Village of Mukwonago
Notice of Meeting and Agenda

PLAN COMMISSION MEETING
Tuesday, June 14, 2022

SITE PLAN AND ARCHITECTURAL REVIEW AND CONDITIONAL USE FOR RIVERVIEW CENTRE

Sign Loc. No. .
MON-02
D/F Monument
Sign. Type
91963
OPP - Project - Job No.
102
Des **26**

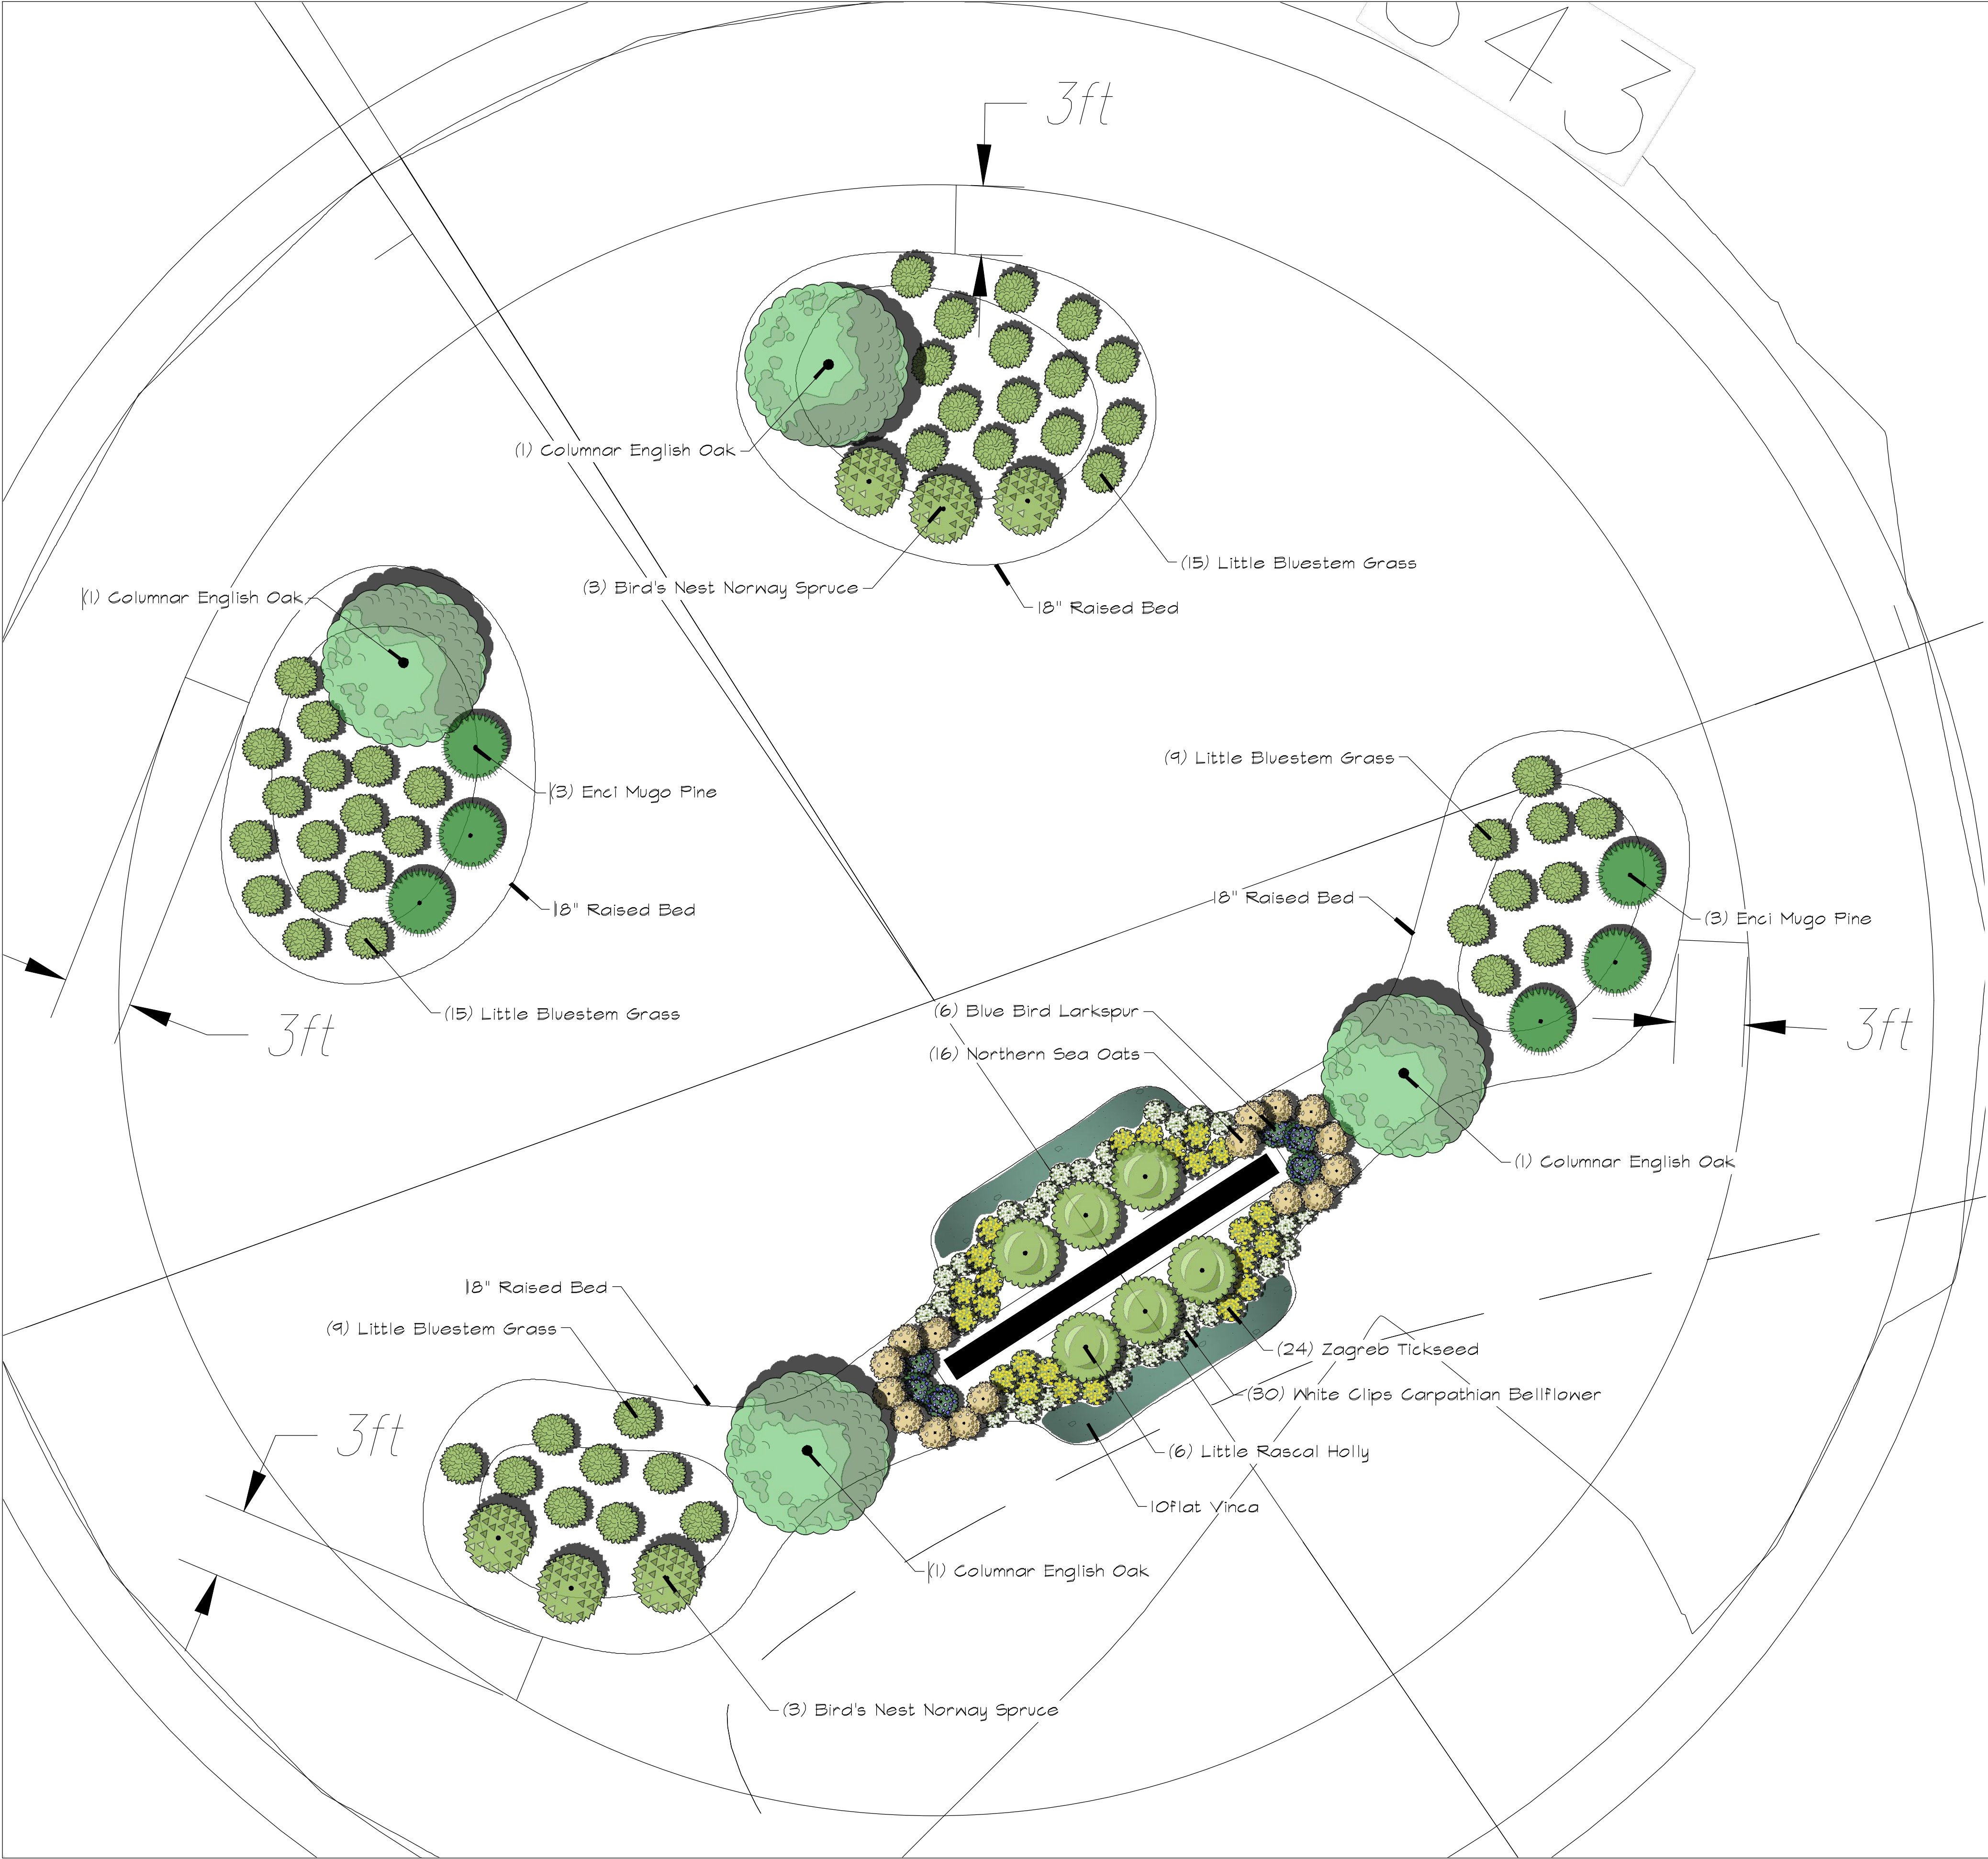
The Plan Commission initially reviewed the petitioner's application on April 12, 2022 and recommended approval. The Village Board reviewed the application and requested the petitioner to come back with another design with enhanced landscaping.

Approve the monument sign as revised subject to the draft resolution (as drafted OR as amended).

RIVERVIEW CENTRE
WEST ELEVATION

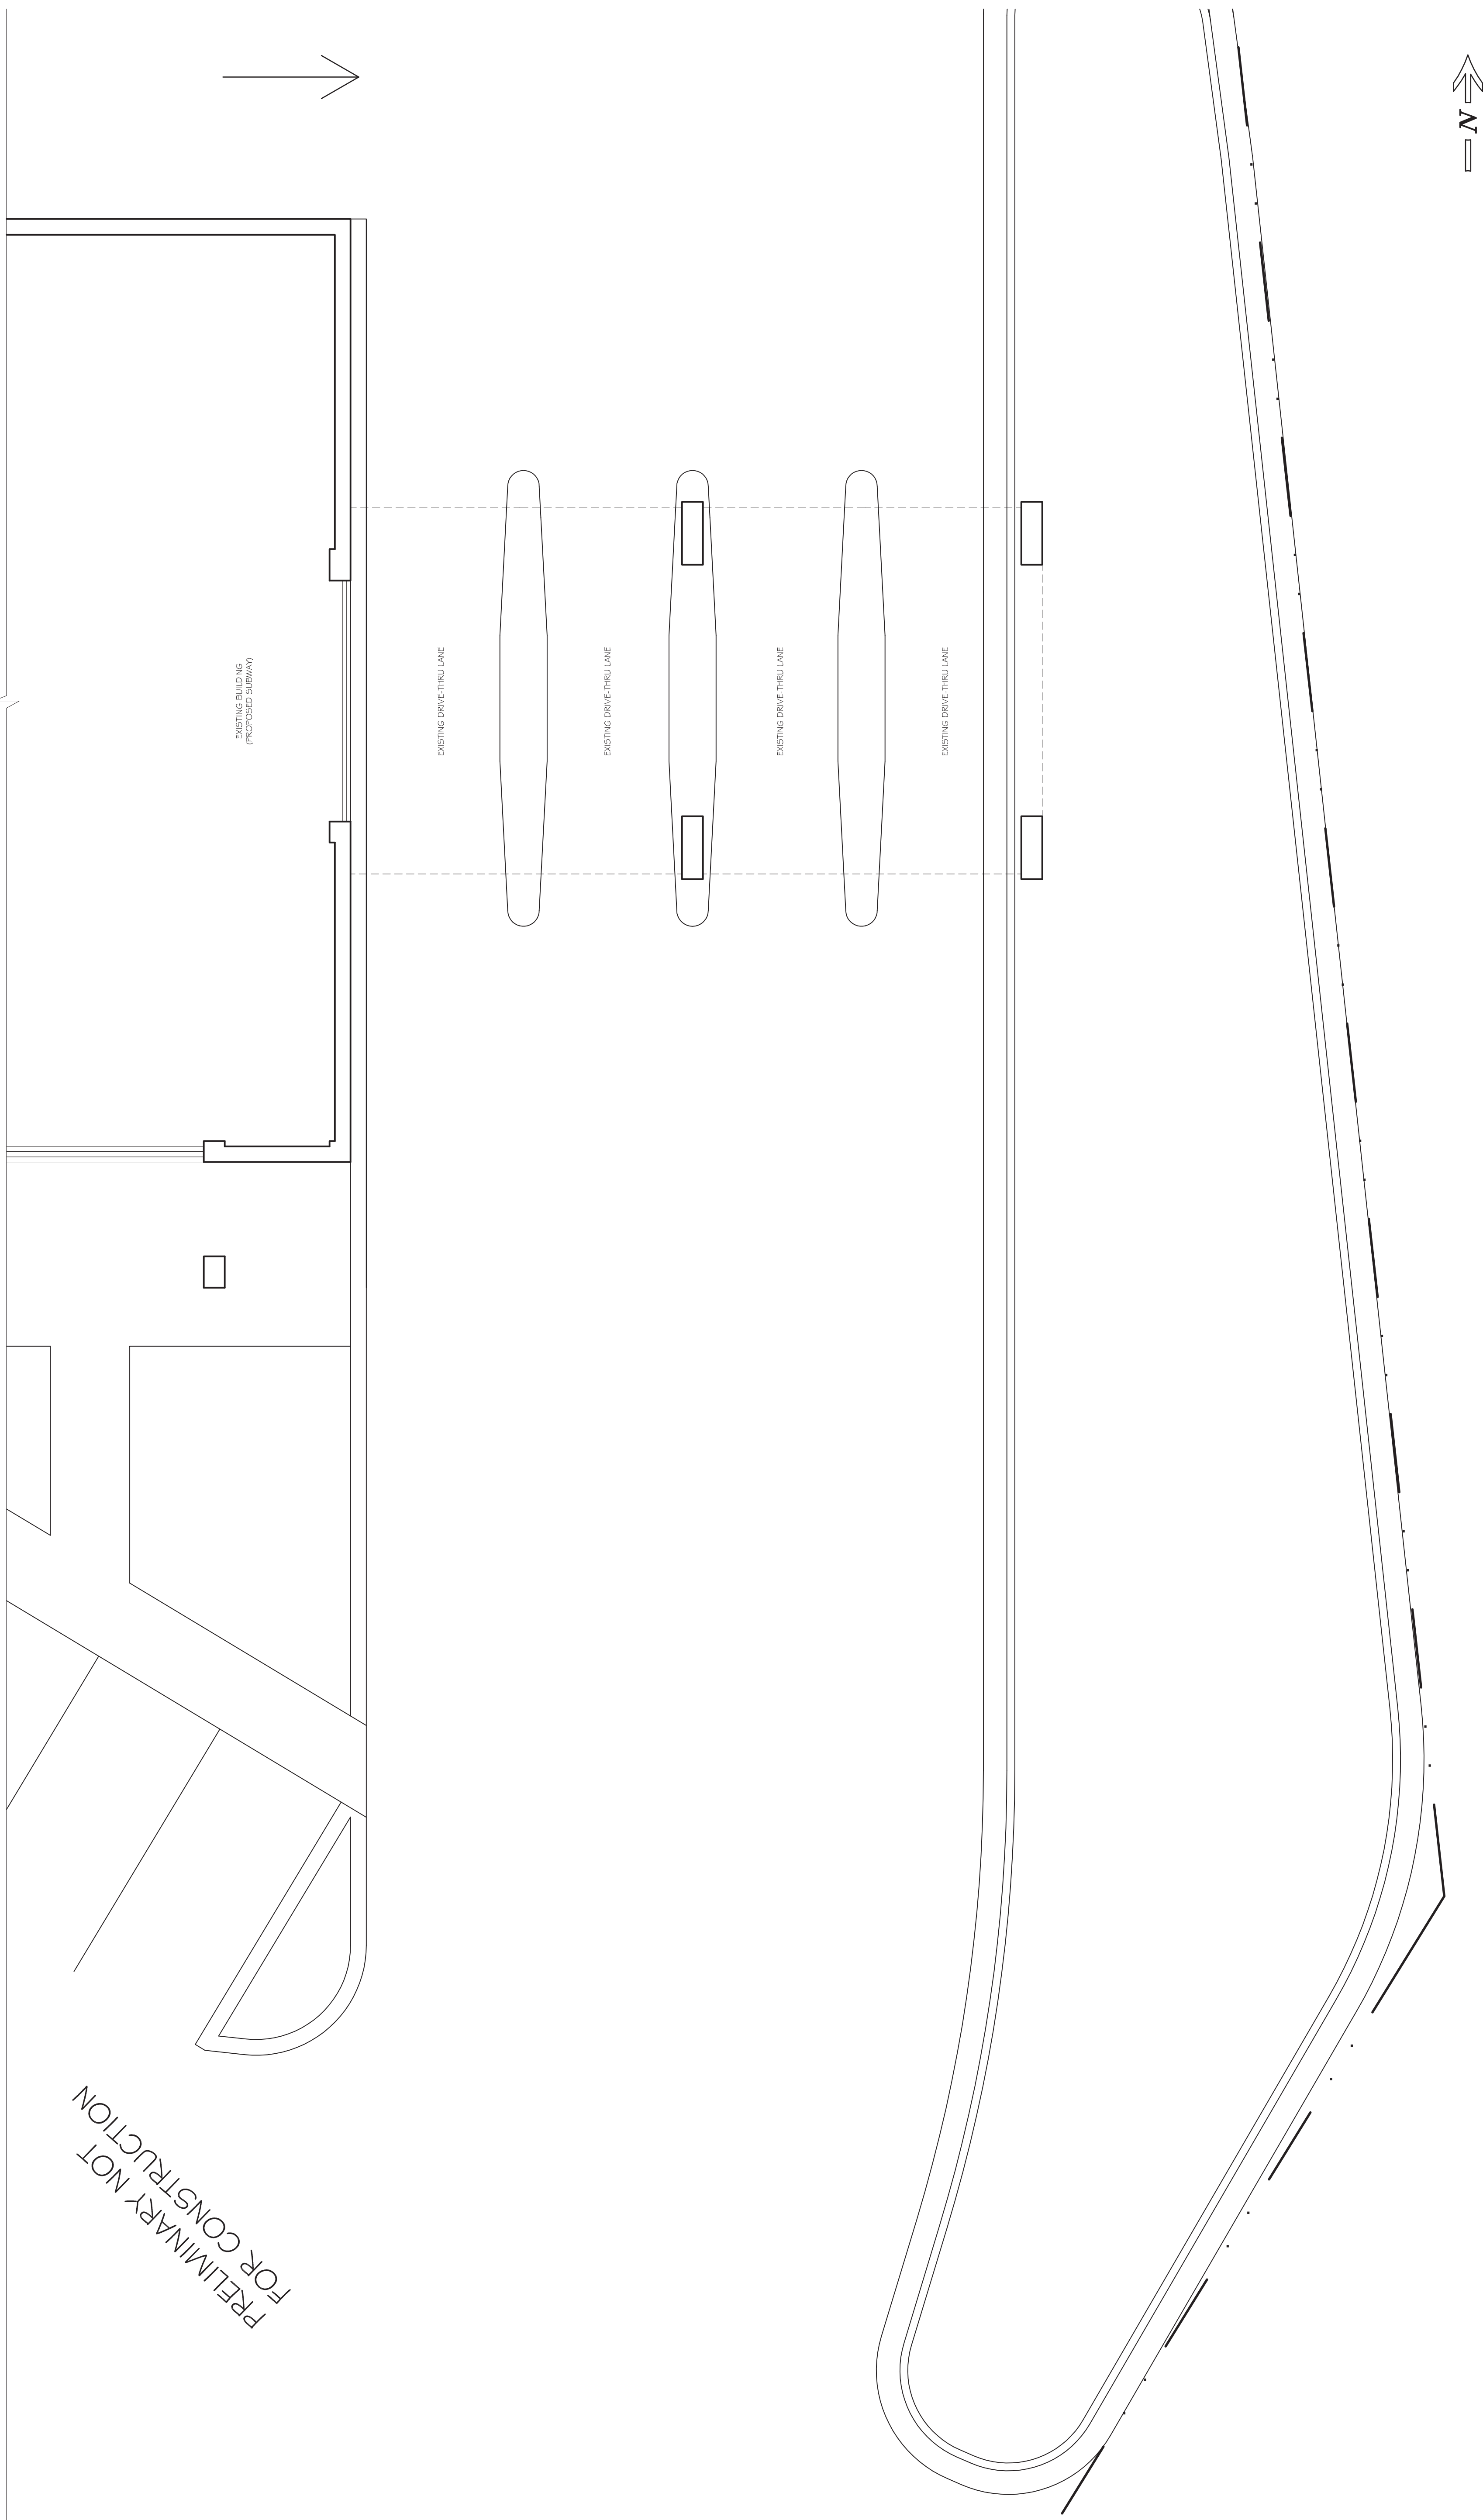
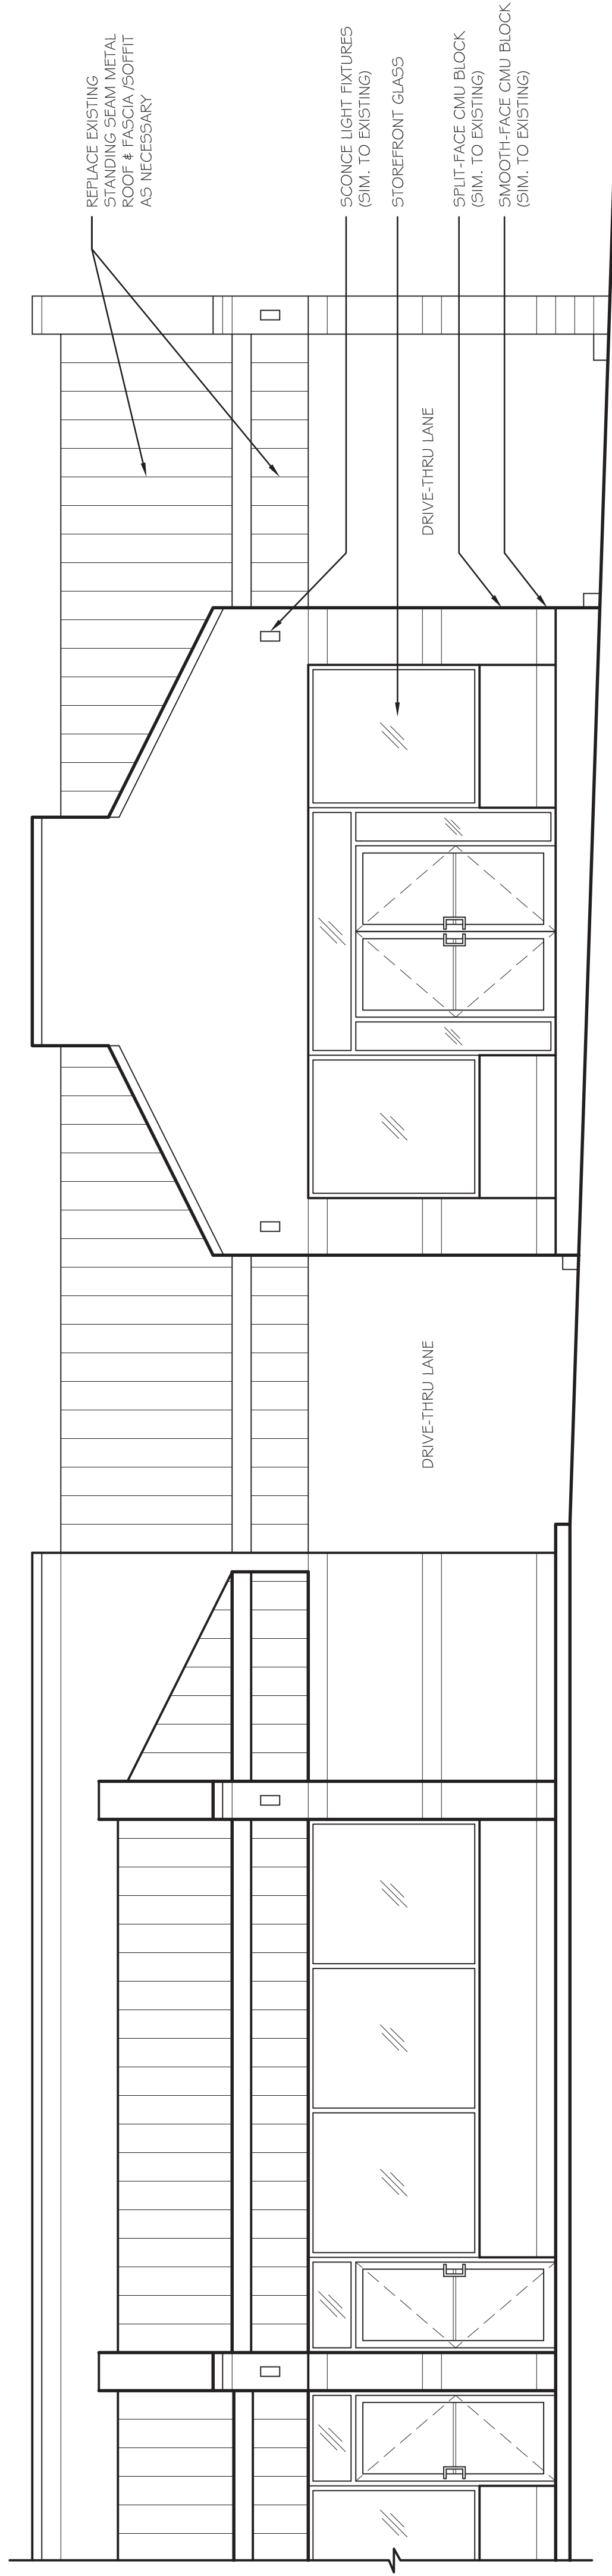
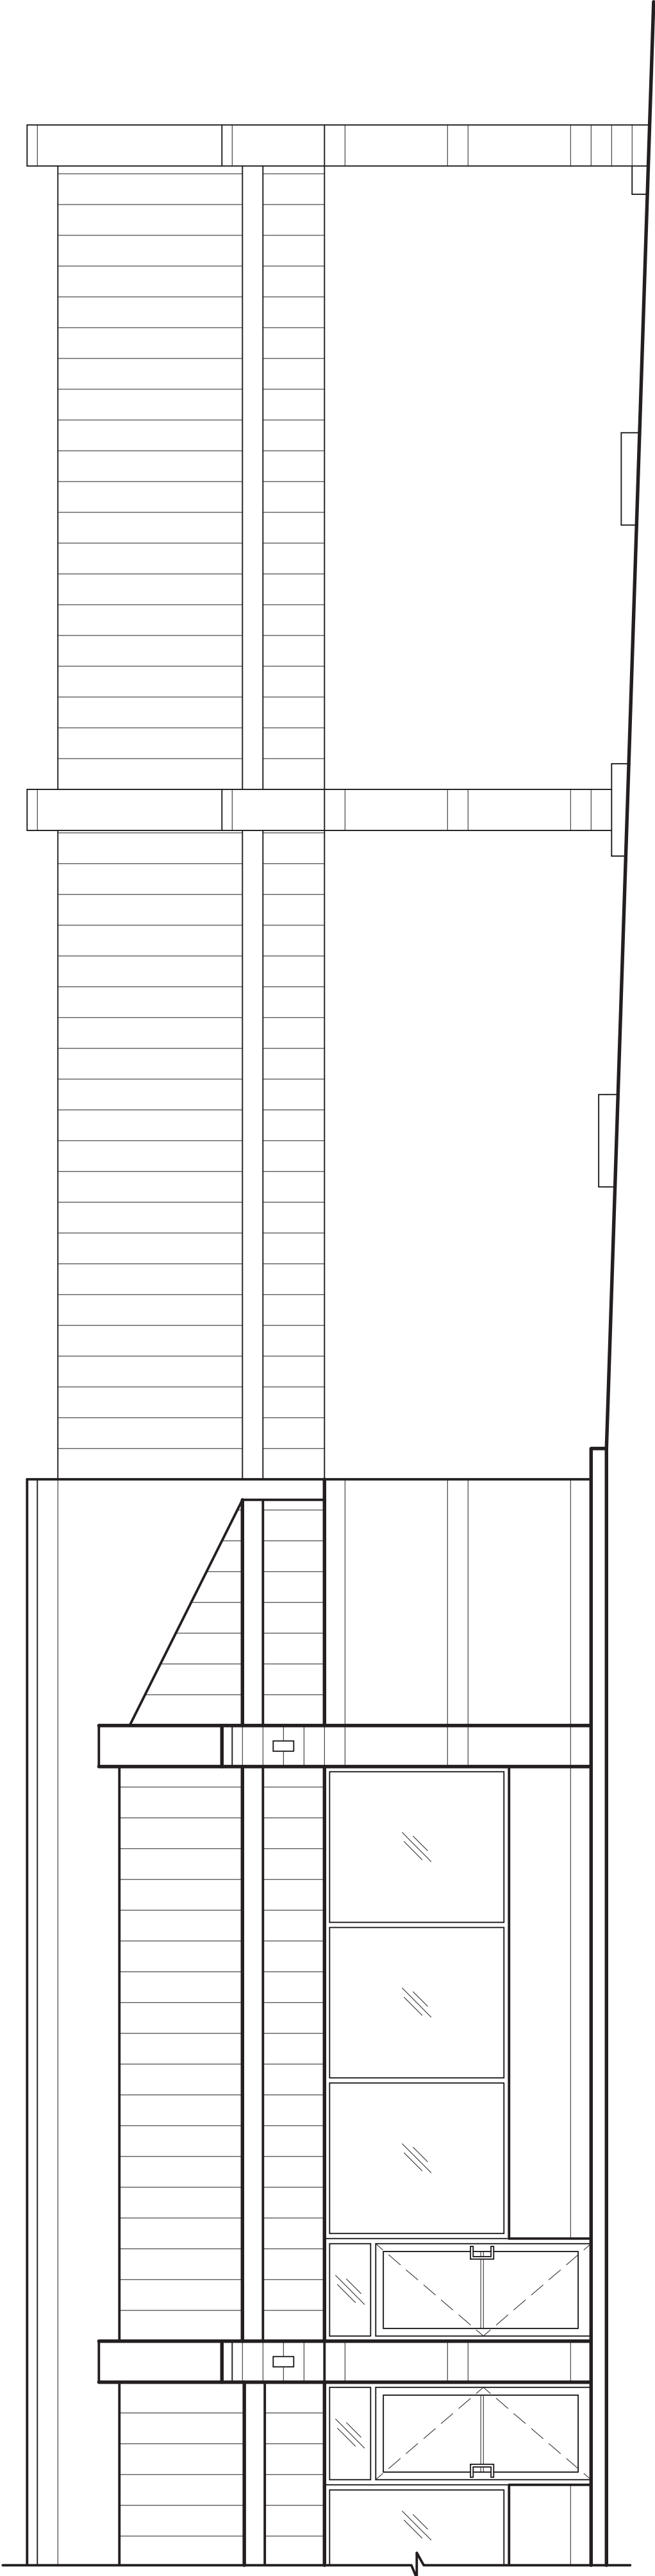
The primary issue with the drive-through lanes is how they are designed to function. The peak demand for the Subway drive-through will likely be less than that for the coffee shop. As shown on the site plan, the proposed layout will only accommodate 6 vehicles in each drive-through. In some instances, queuing vehicles may block the traffic lanes within the parking lot area. Public safety related to the movement of vehicles and pedestrians needs to be thoroughly evaluated before issuing the conditional use approval for the drive-throughs.

The site plan has been revised and now shows a speed bump and directional signs on the northeast corner of the building. In addition, a turning movement is depicted for a vehicle and a boat trailer exiting the coffee drive-through lane and shows the vehicle will need to cross the centerline to make the corner.

Decorative fencing is proposed around the outdoor patio by the front door. The plans do not show where any HVAC mechanicals will be located. That needs to be addressed.
